Re: Softball Complex Sulphur Springs Park

JHH No.: 21-027B

Proposed Change Request 11: Topsoil for project & Overhead Costs

C304

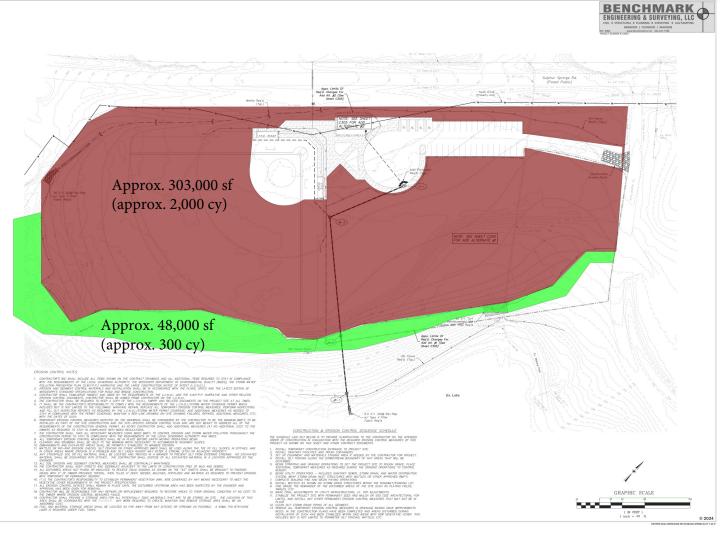
On the afternoon of Friday, April 11th, Drew Ridinger, Jamey Sudbeck, Laura Sudbeck, and I inspected the top soil stored by Madison County that was intended to be used on this project. It was determined that the material is not satisfactory. S & S Excavation has provided a price of \$38/CY for the first 2,000 cubic yards of topsoil to be delivered to the site. This \$38/CY is for the dirt and hauling as the cost of placing the topsoil was included in our bid price for this project. The dirt cost plus bonds, insurance, and MPC tax totals \$80,057.00. We also request an additional 18 days be added to our contract for this delay anticipating approval for this PCR will be received no later than April 24th. We have submitted a soil sample to Ladner Testing Services to verify the soil is acceptable for use on this project.

Required topsoil over the 2,000cy noted above, will be placed for \$60/CY (contract unit cost). This cost covers the cost of the topsoil, hauling and placing the topsoil over and above the contract limits added by PCR 8 for slope improvements. We estimate 300 cubic yards of topsoil will be required at an additional cost of \$18,000. As this is a unit cost, no markup is allowed.
